Disconnect Switch – Wiring

Bulletin Type:	Technical Service Bulletin TSB	Publication Date:	August 2020
Bulletin #(s):	20-017	Make(s):	Jayco
Job Code(s):	9801511A Inspect ONLY .2 9801511B Inspect and Repair .75	Model(s):	White Hawk Jay Feather
		Model Year(s):	2020-2021

Incident:	Wiring of the Disconnect Switch may be incorrect.
Affected Units:	Please see Unit Listing at end of Instructions
Parts Kit:	Parts Kit #: 20-017J
	Parts Kit Contents: (2) large blue wing nuts
Misc. Tools & Supplies:	12-volt DC capable multi-meter 12-volt DC battery or battery jump pack 120-volt AC power source (to plug trailer into) Wire strippers Screw gun with square and Phillips tip bits Flashlight or external light source

Photos represent wire configuration 1

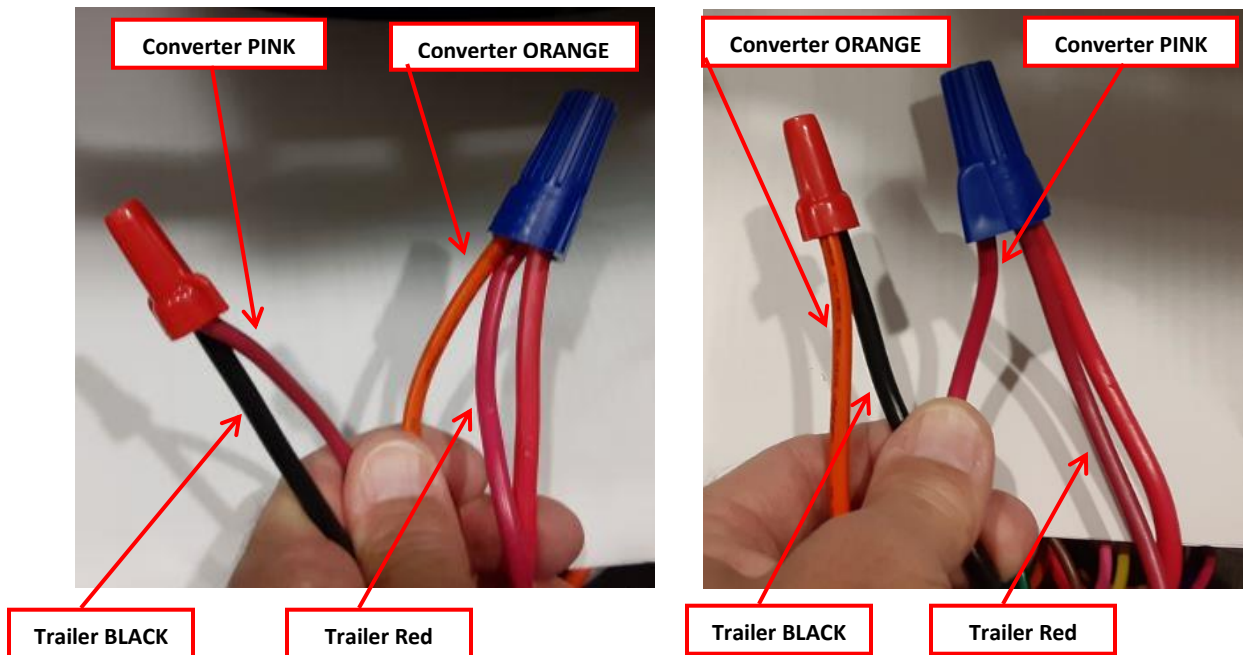
Wire configuration 1 (see photos)

Original connection

Converter Pink 10-gauge wire connected trailer with the Black 10-gauge wire, **AND**
Converter Orange 10-gauge wire connected with the trailer Red 10-gauge wire

Change the wire connections so that:

Converter Pink 10-gauge wire connects with the trailer Red 10-gauge wire, **AND**
Converter Orange 10-gauge wire connects with the trailer Black 10-gauge wire

Wire configuration 1:

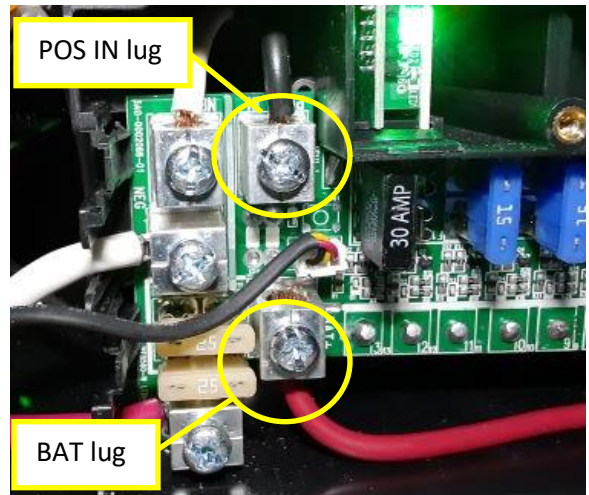
Original connection

Trailer Red 8 gauge wire is connected to circuit board "BAT +" lug,

AND

Trailer Black 8 gauge wire is connected to circuit board "POS IN+" lug

Change the wire connections so that:

Trailer Black 8 gauge wire is connected to circuit board "BAT +" lug,

AND

Trailer Red 8 gauge wire is connected to circuit board "POS IN+" lug

Wire configuration 2:

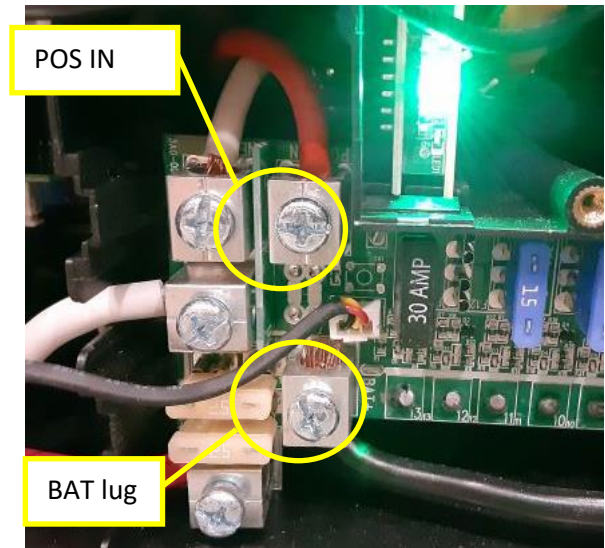
Original connection

Trailer Black 8 gauge wire connected to circuit board "BAT +" lug,

AND

Trailer Red 8 gauge wire connected to circuit board "POS IN+" lug

Change the wire connections so that:

Trailer Red 8 gauge wire connects to circuit board "BAT +" lug

AND

Trailer Black 8 gauge wire connects to circuit board "POS IN+" lug
